**SUBJECT: P&WC SERVICE BULLETIN (SB) No. 14498**

P&WC S.B. No. 14498

TURBOPROP ENGINE  
POWER TURBINE STATOR HOUSING - INSPECTION OF

**PT6A-72-14498**  
Cover Sheet

Power Turbine Hardness Check Inspection.  
Figure 1

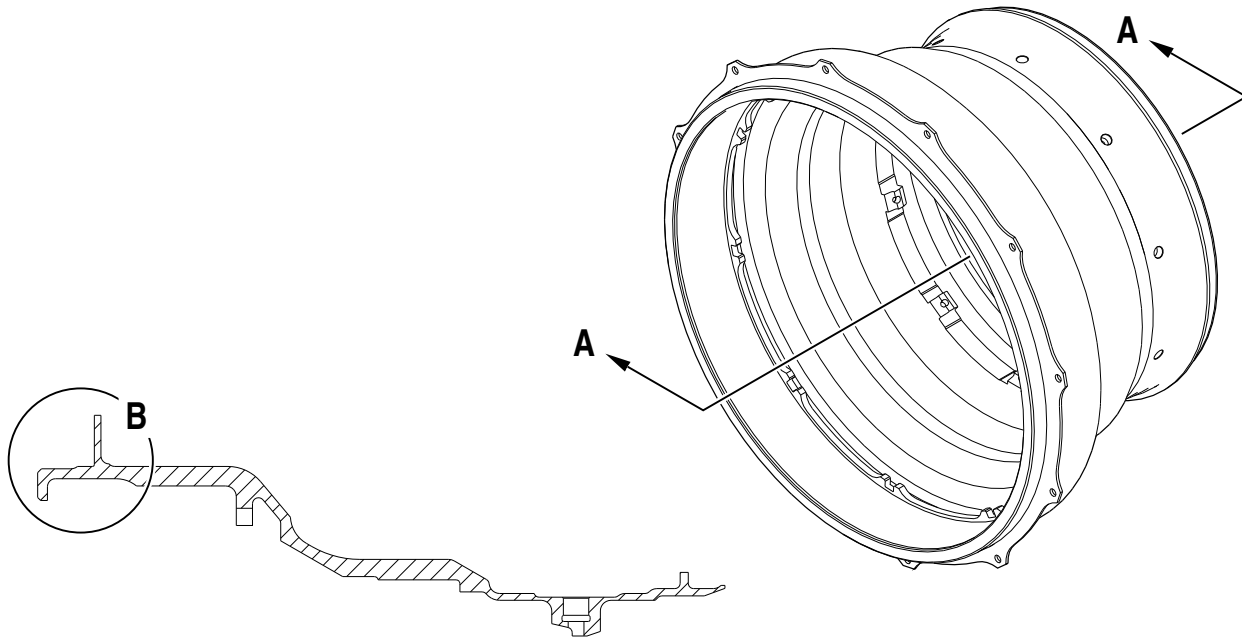
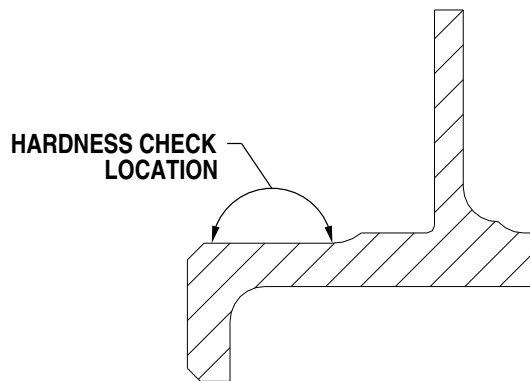
- (1) For power turbine stator housing P/N 3121524-01 or 3043706-01 weld repaired per OHM dated Mar 24/2014 in another facility (not P&WC Service Centers or P&WC DOFs), measure the hardness of the part at two (2) locations equally apart on the area shown. (Ref. Fig. 1).

- (a) If the measured hardness check is equal to or more than 36 Rockwell C do as follows:

**HARDNESS MUST BE 36 ROCKWELL C MINIMUM.  
DO NOT MEASURE THE HARDNESS ON THE ADJACENT RADIUS.**

- 1 Use the vibration peening procedure, 0.003 to 0.006 in. (0.08-0.15 mm) deep, and write SB 14498 after the part number.

(b) If the measured hardness check is below 36 Rockwell C, do as follows:

- 1 Do a full heat treatment to the power turbine stator housing per SPOP 474-1.
- 2 Fluorescent penetrant inspect the power turbine stator housing per SPOP 62.
- 3 Dimensionally inspect the surface and position tolerances of the anti-rotation lugs and the sealing diameter for distortion in accordance with the applicable overhaul manual instructions (Ref. OHM 72-50-03 POWER TURBINE INTERSTAGE - REPAIR).

- 4 Use the vibration peening procedure, 0.003 to 0.006 in. (0.08-0.15 mm) deep, and write "RE 14498" to indicate heat-treat completed, after the part number.
